ATTACHMENT 5

Letter from M. E. Warner (NMC)

License Amendment Request 187

Revised Pages for Updated Safety Analysis Report
(USAR)

Figure 14.1.6-9

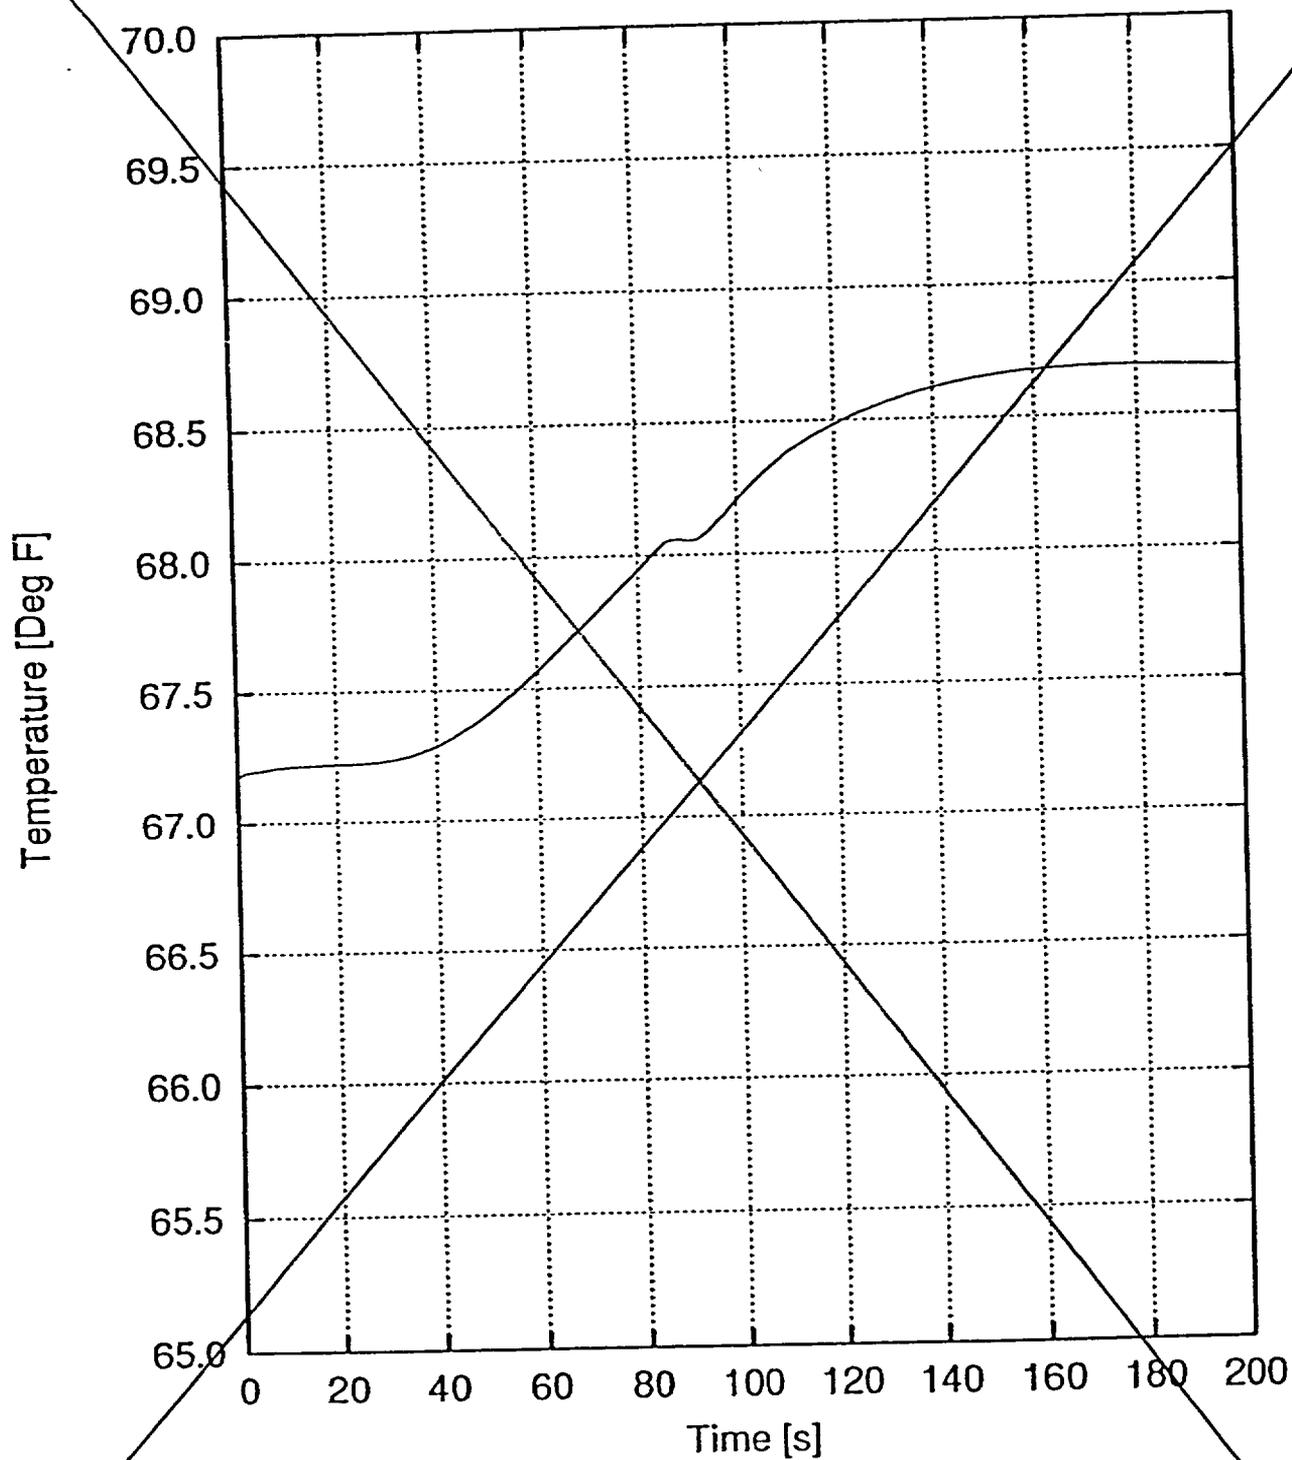
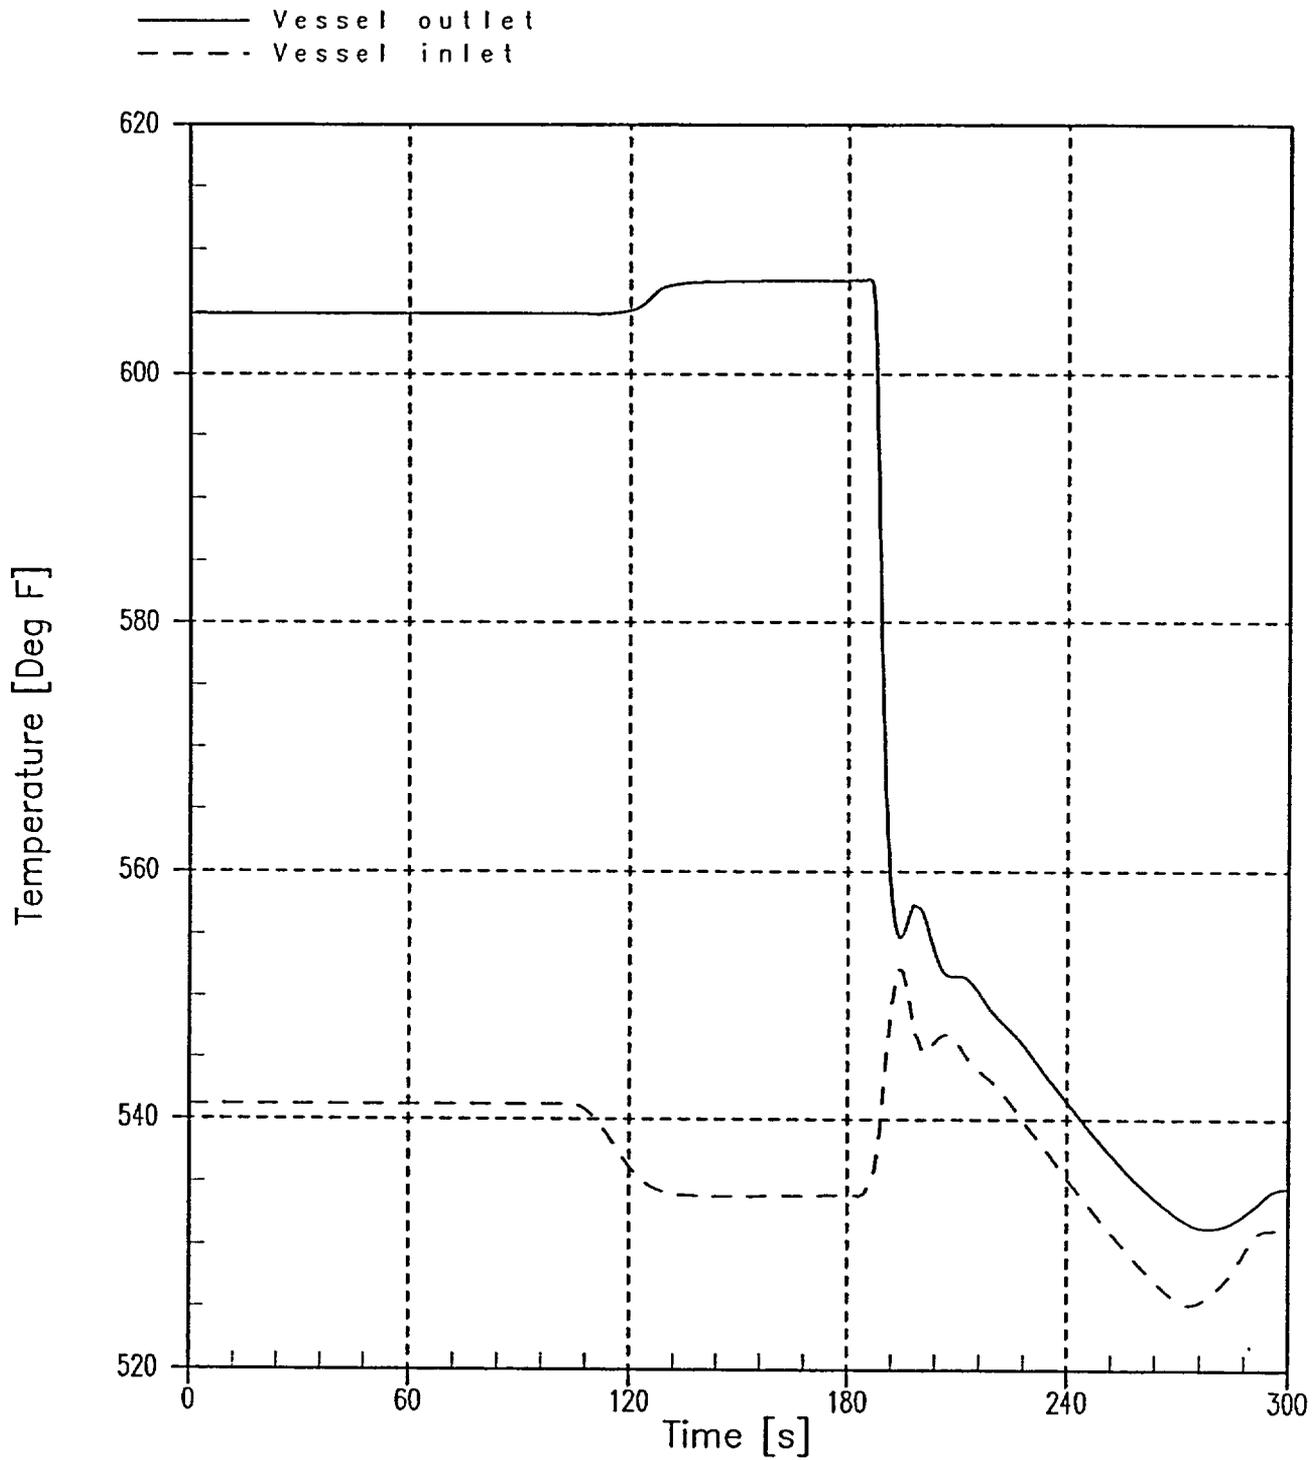
REPLACE WITH FIGURE 14.1.6-9 (ON FOLLOWING PAGE)

Figure 14.1.6-10

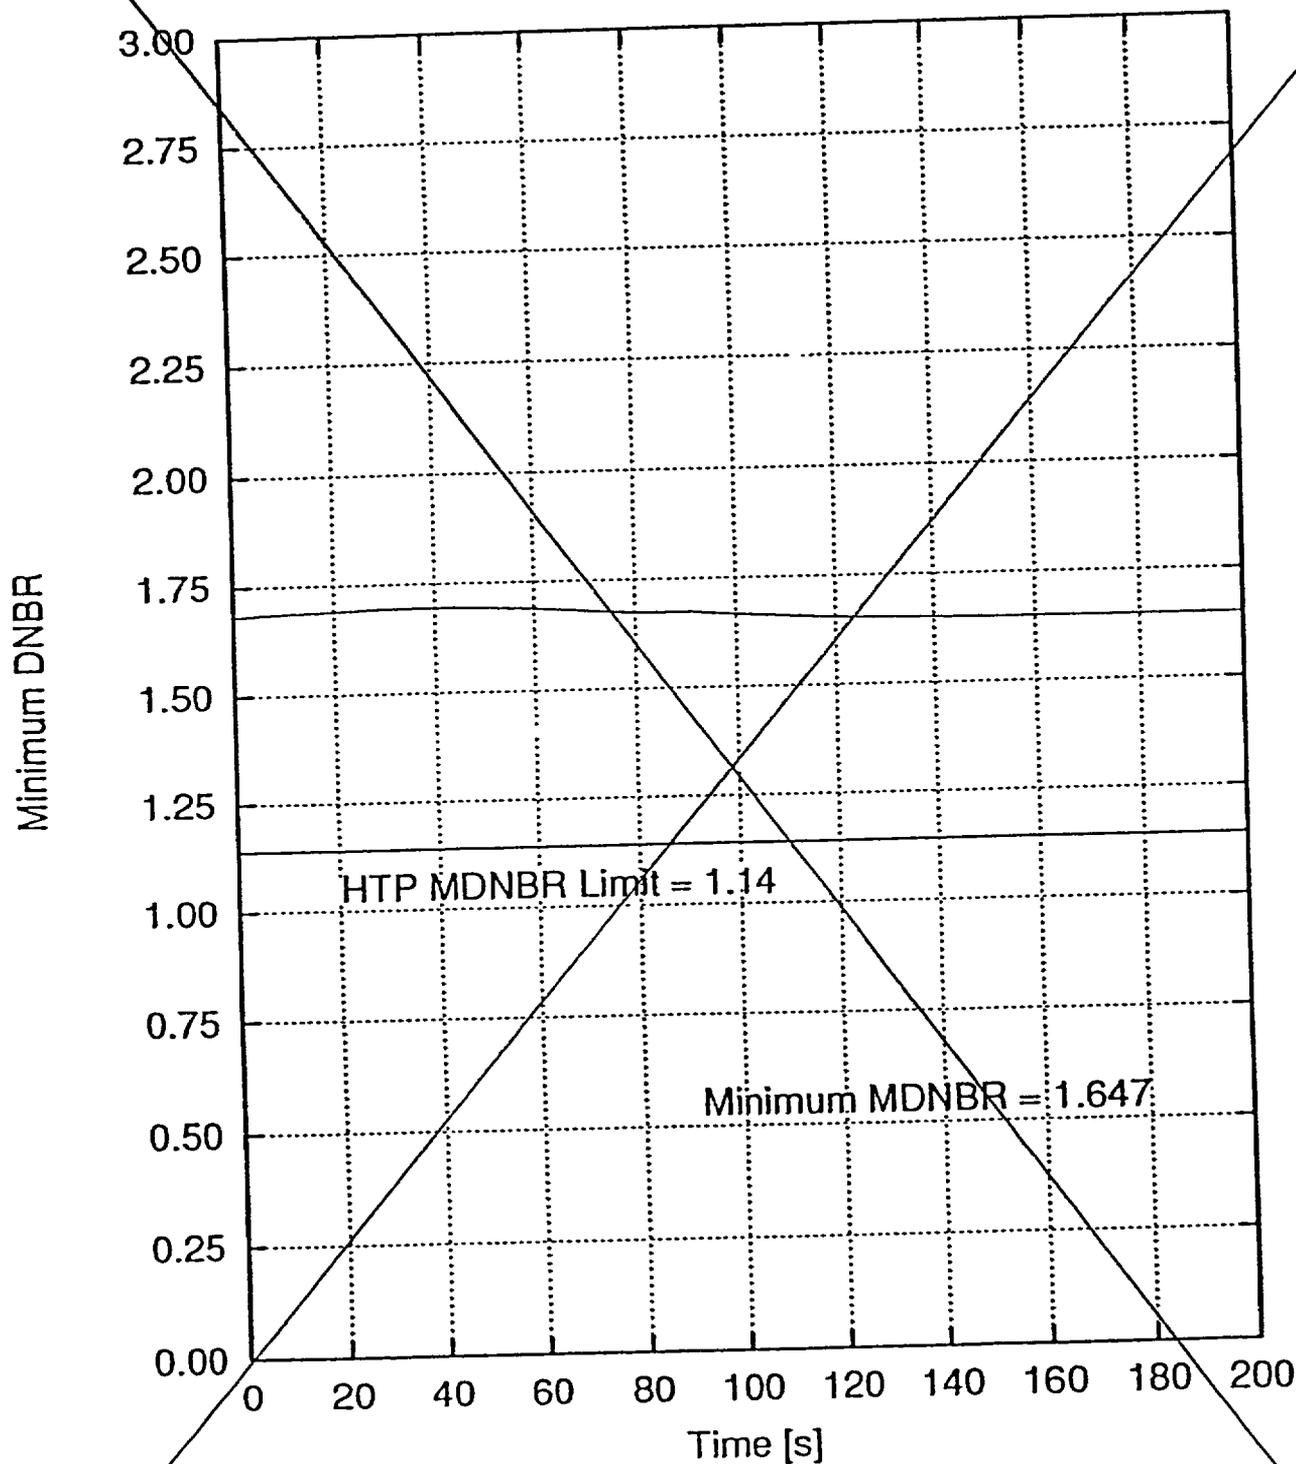
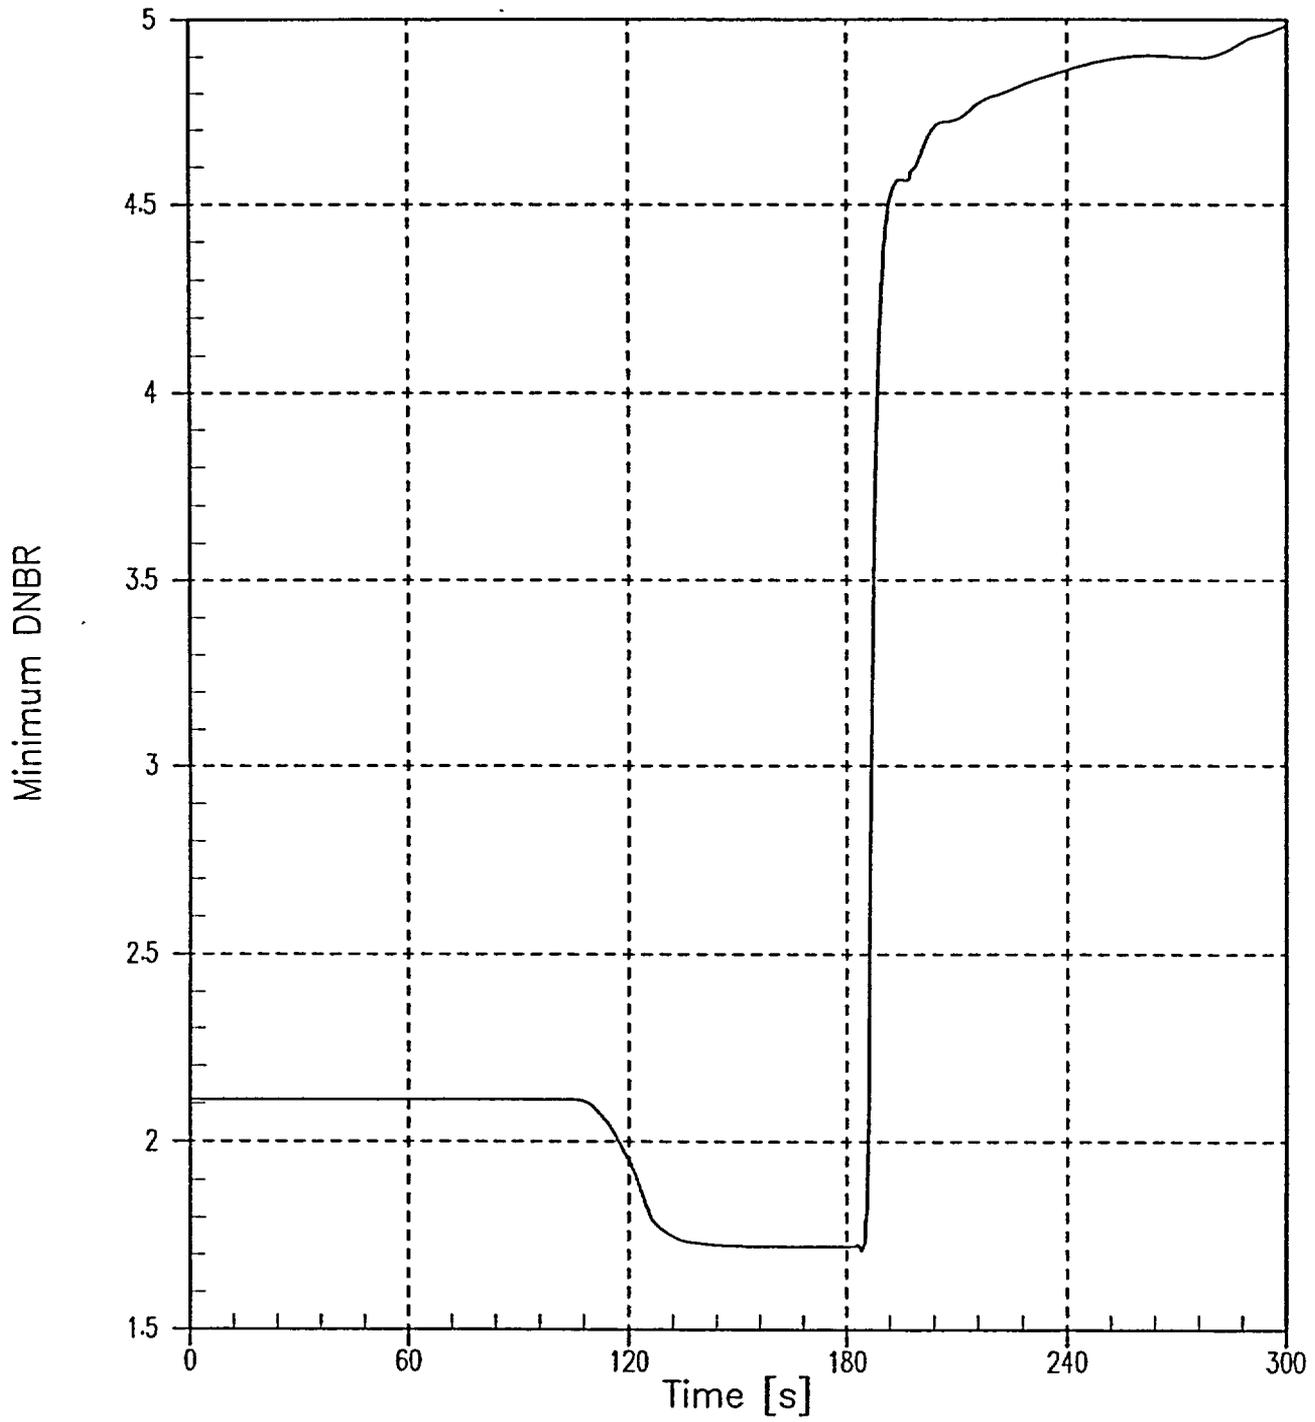
REPLACE WITH FIGURE 14.1.6-10 (ON FOLLOWING PAGE)

Figure 14.1.8-1

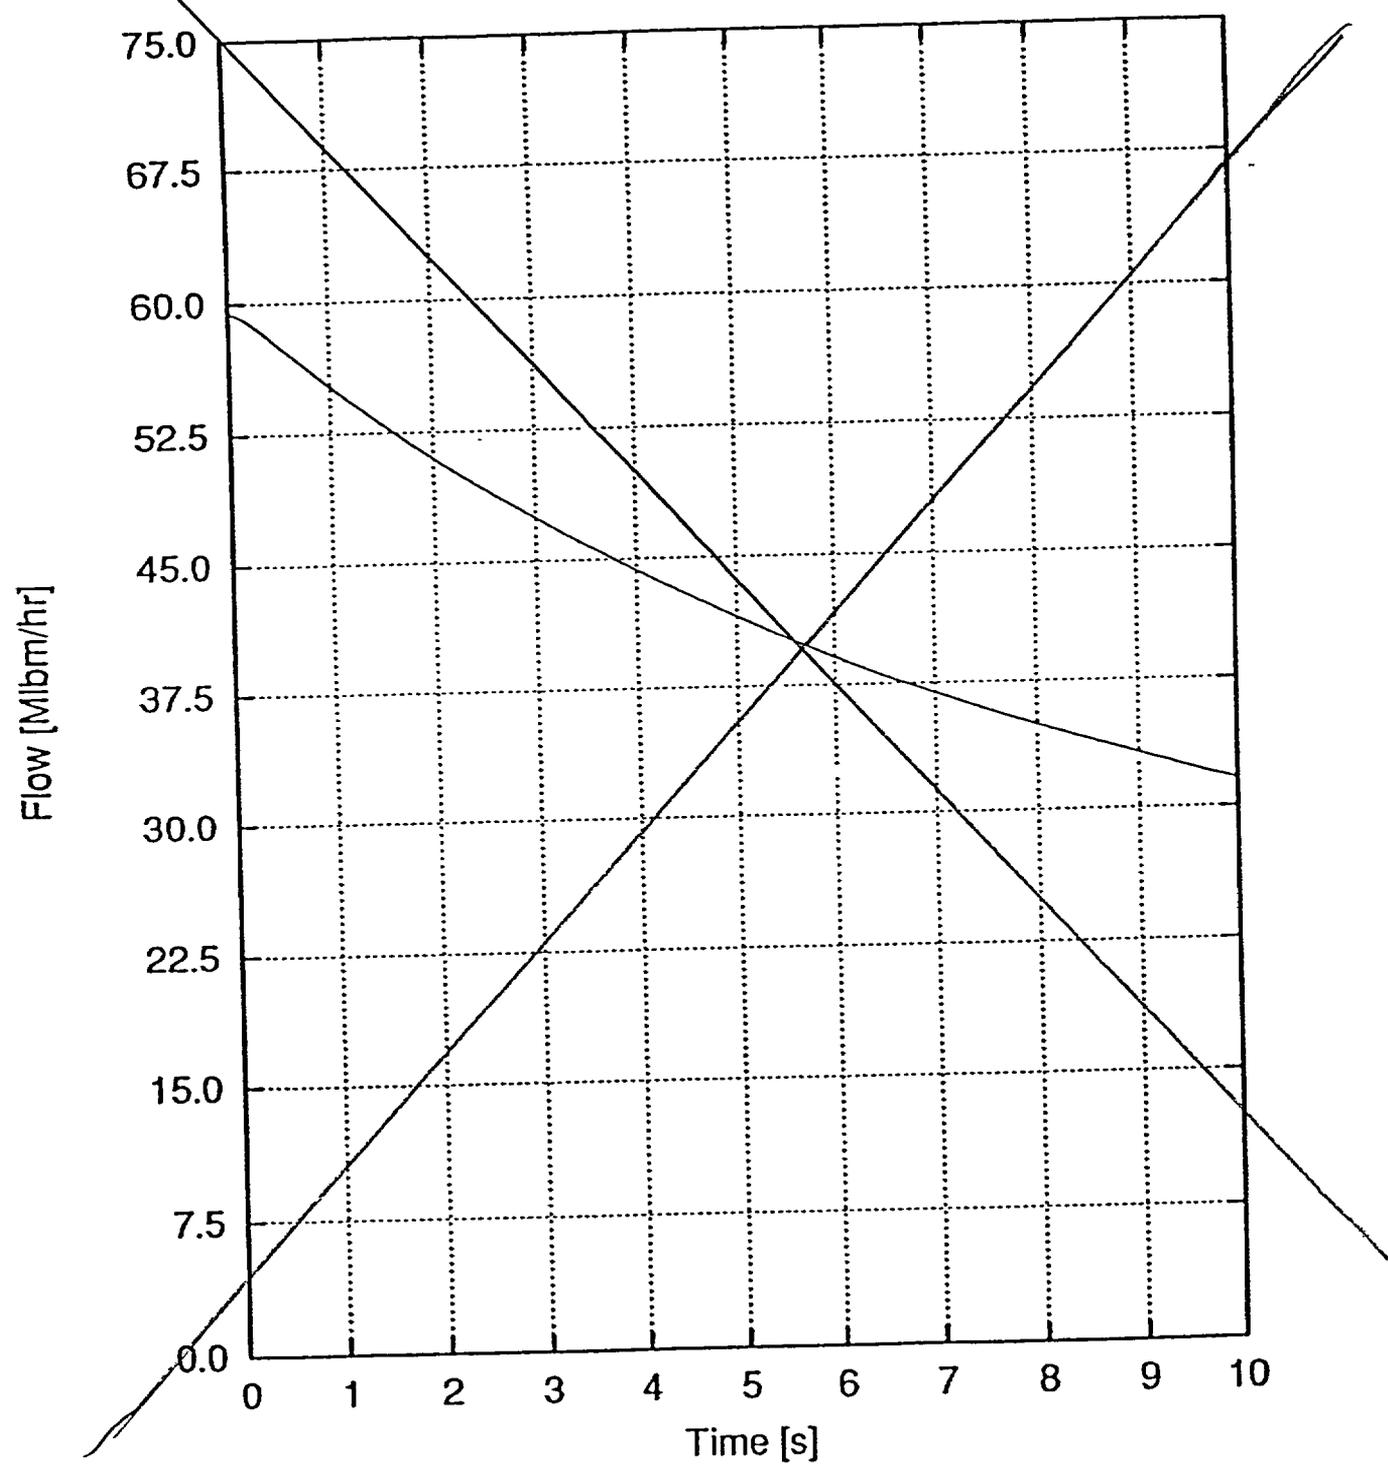
REPLACE WITH NEW FIGURE 14.1.8-1

Figure 14.1.8-2

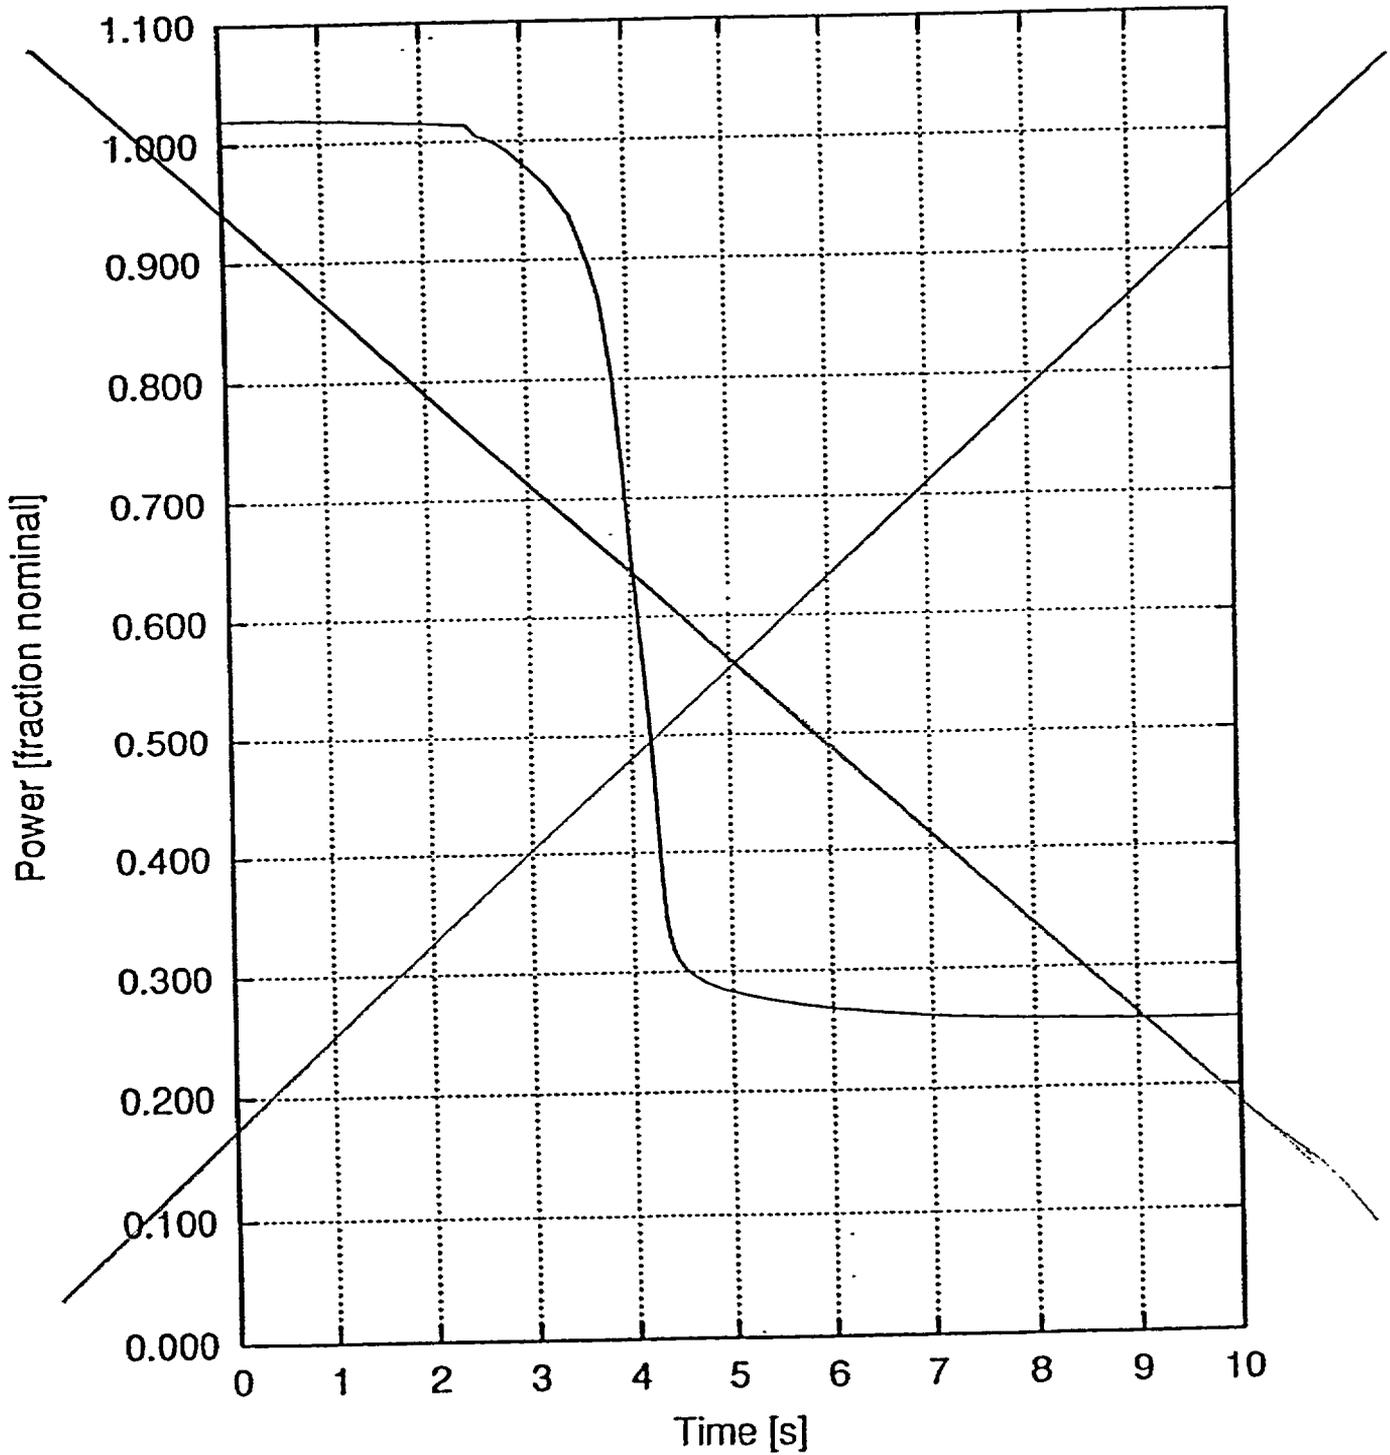
REPLACE WITH NEW FIGURE 14.1.8-2
